SOUTH FAYETTE TOWNSHIP

Planning Commission Meeting Agenda

A. Review And Discuss S-02-2026 Smith Henney Lot Line Adjustment Plan, Preliminary And Final Minor Subdivision Application, Parcels 328-G-13 & 328-G-30, Zoned R-2.

C. Review And Discuss F-01-2026 Hastings Phase 5, Preliminary And Final Major Subdivision Application, Parcel 571-A-10, Zoned ND, Neighborhood Design.

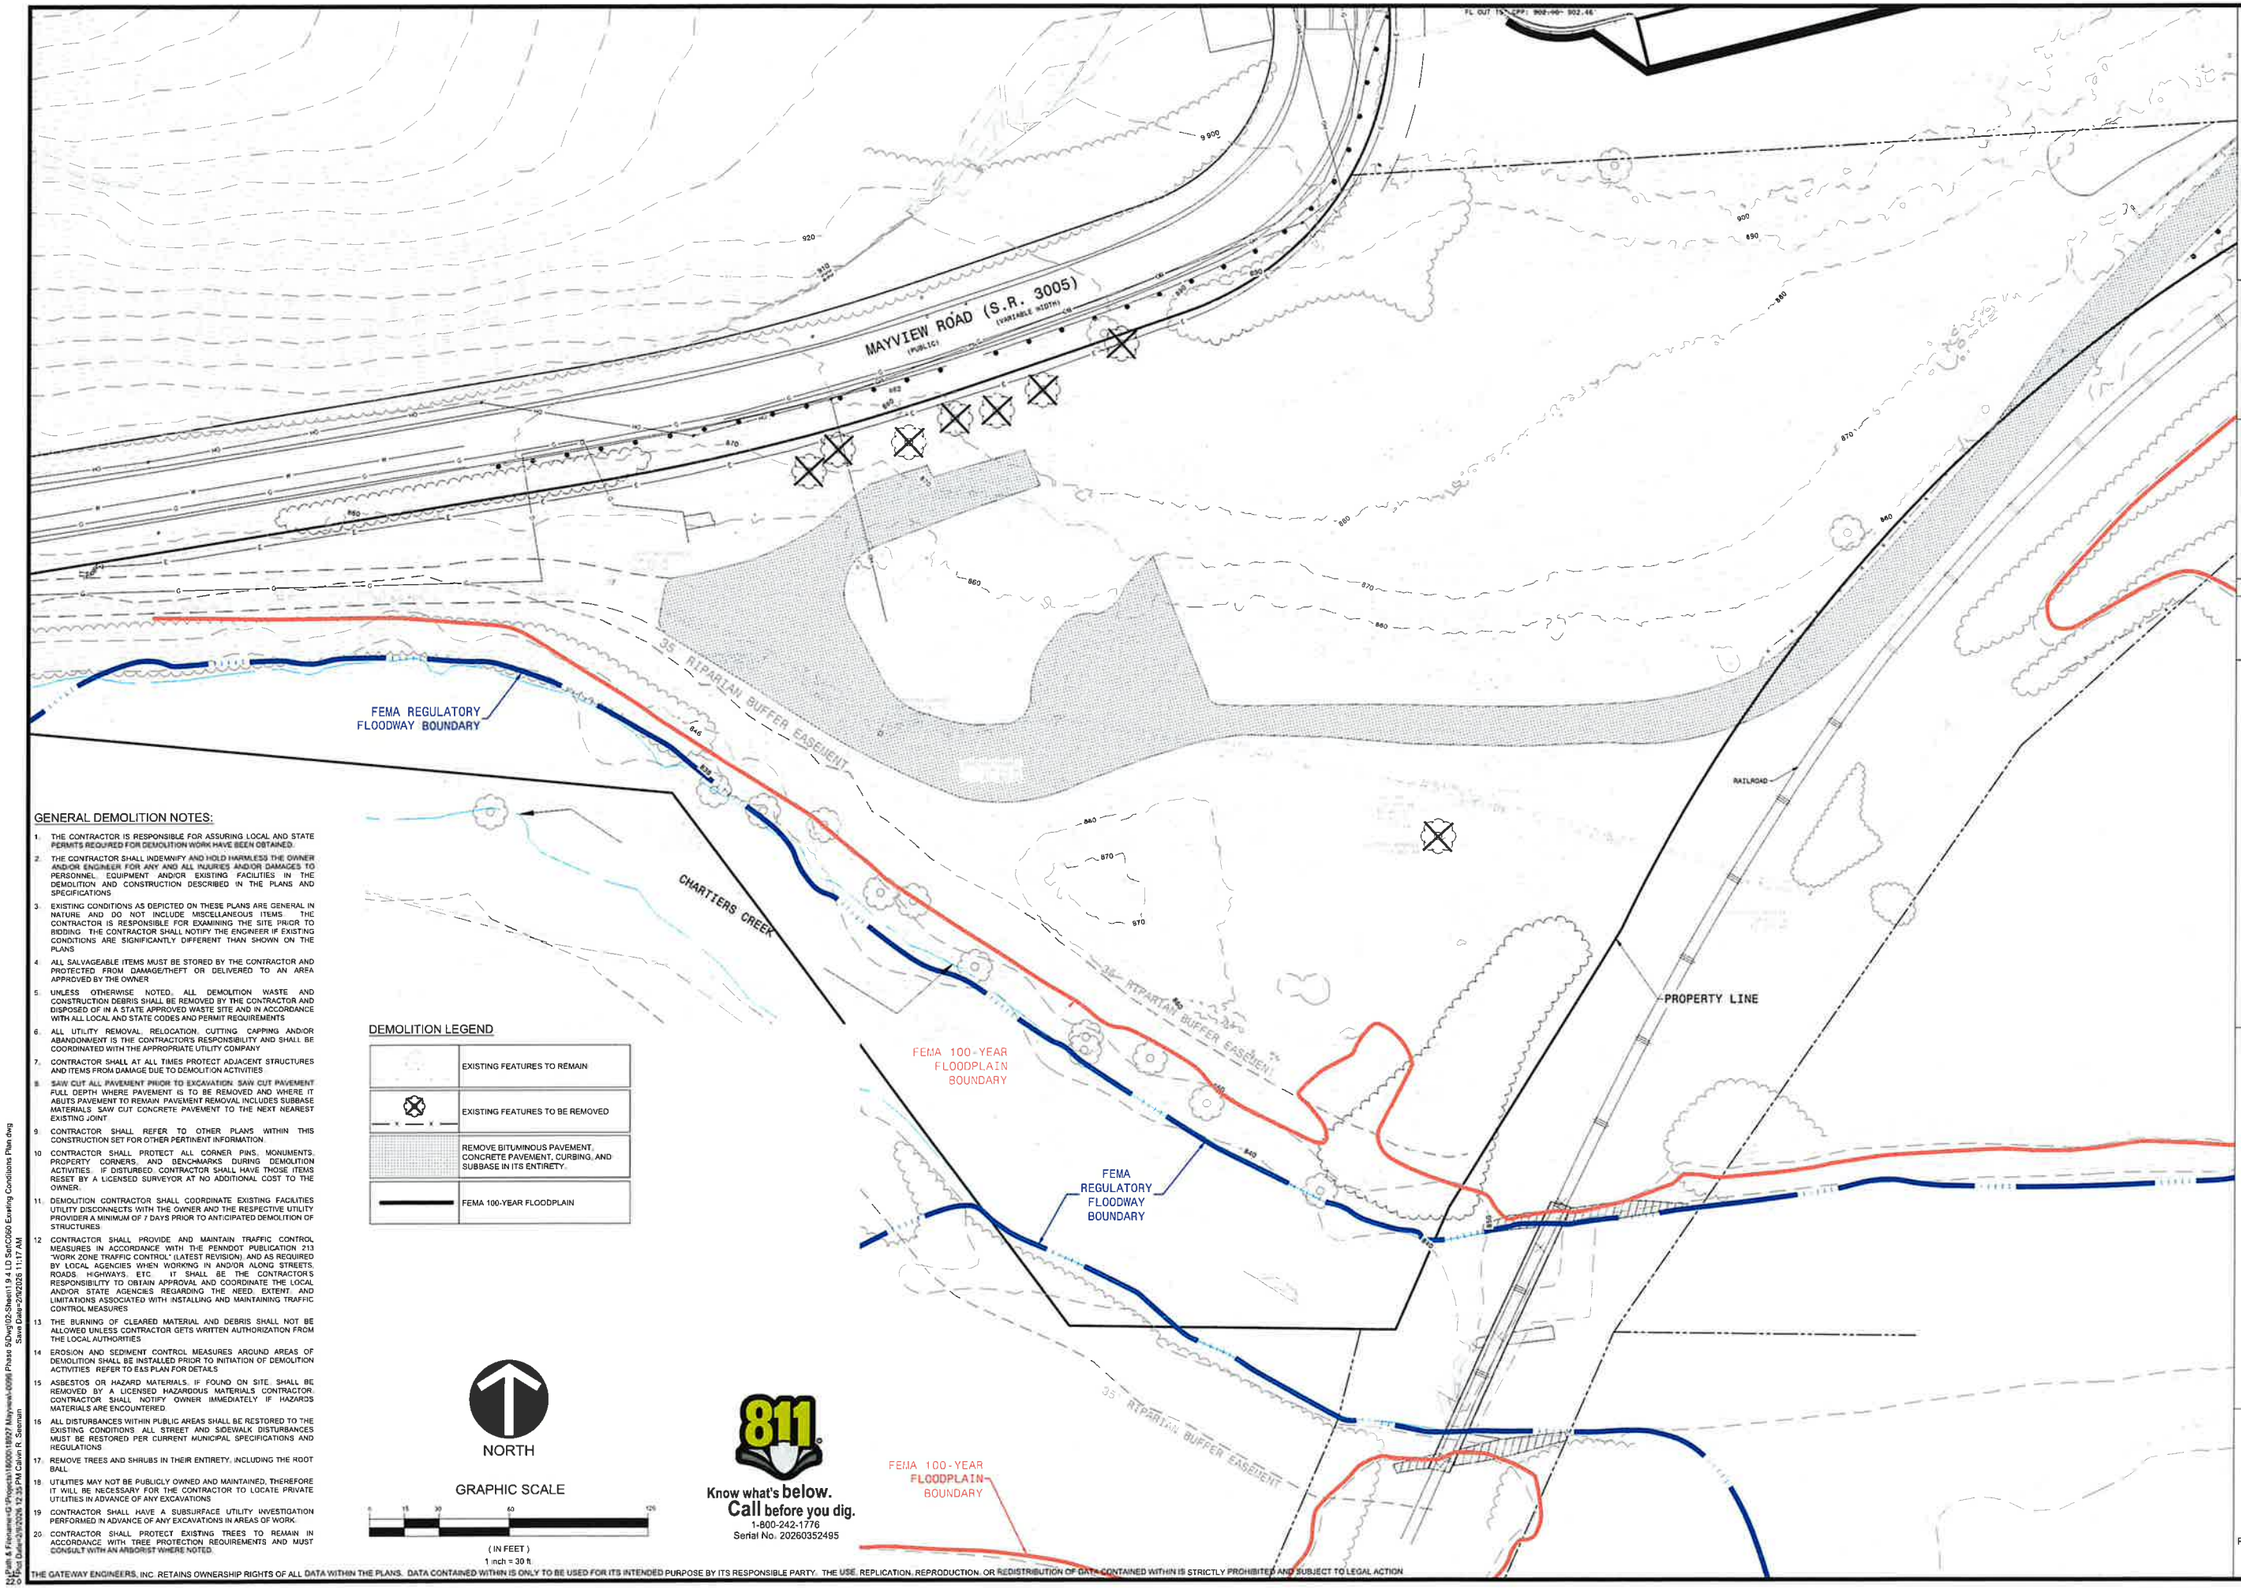
7. On the List of Utilities on Drawing C000, update MATSF's address to 700 Holland Street.
